**Honda CB350K4**

Name Of Part **Fork Modification**

*Nova Racing Transmissions Ltd*

6th Output Fork

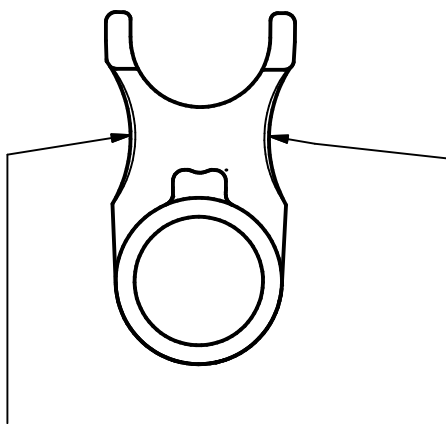
Remove 3mm Of Material  
From This Side

Remove material from this  
side of the 6th fork to allow  
the fork to clear the input  
shaft gears whilst shifting.

5th Output Fork

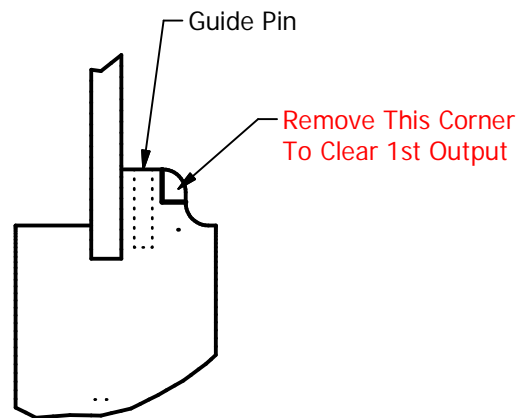
Remove 3mm Of  
Material From This Side

Remove material from this  
side of the 5th fork to allow  
the fork to clear the input  
shaft gears whilst shifting.
